XPROG-m Errata Sheet 001

This errata provides information applicable to the following products:

- 1-002-0017 programming adapter Rev.B or earlier

STEP1

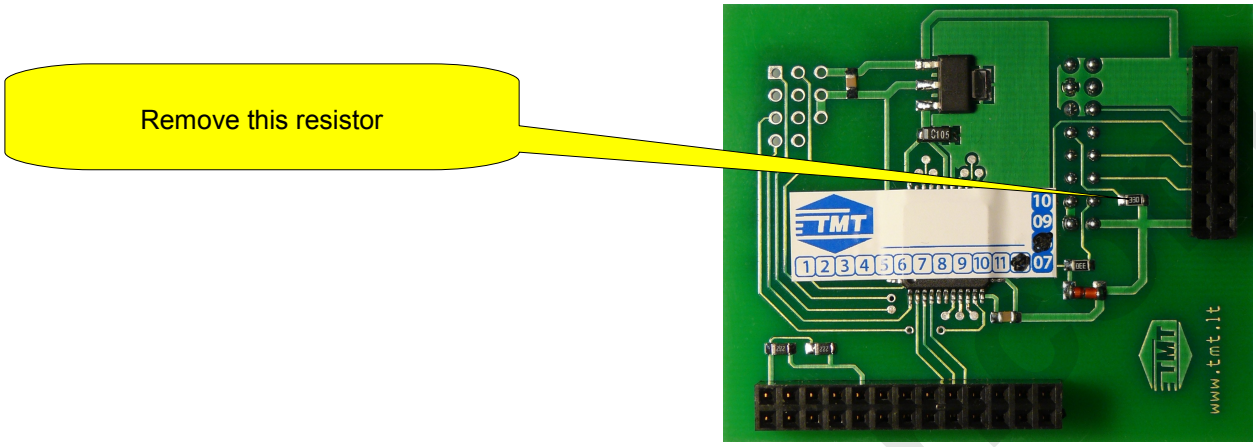
These changes allow you to work with secured ARM MCU via JTAG interface

STEP2

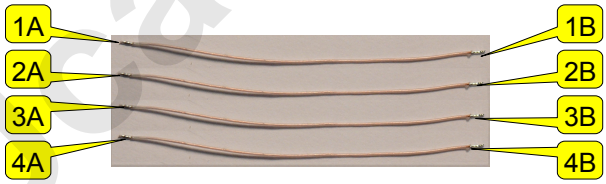
- Prepare the four wires. About 5cm in length.

STEP3

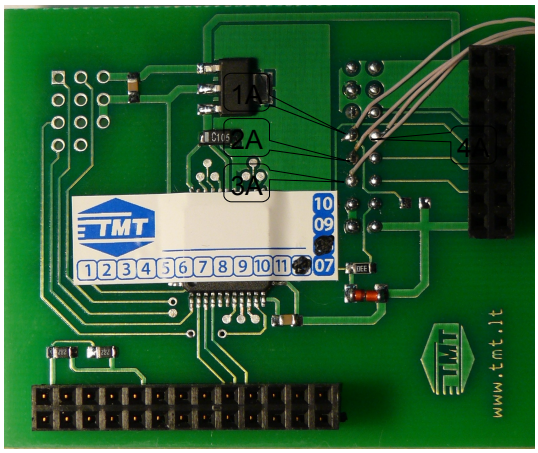
- Solder wire shown in the corresponding points at the bottom side

STEP4

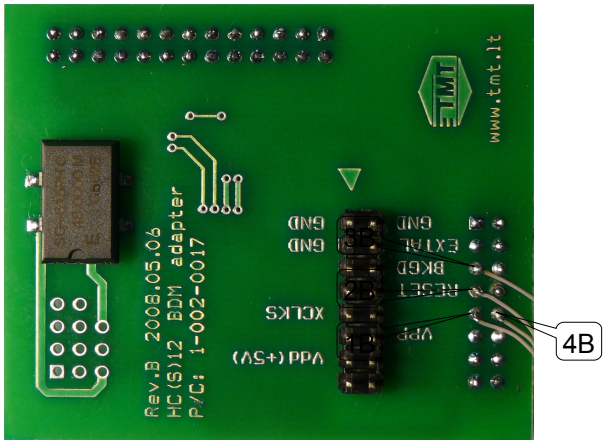
- Solder wire shown in the corresponding points at the top side
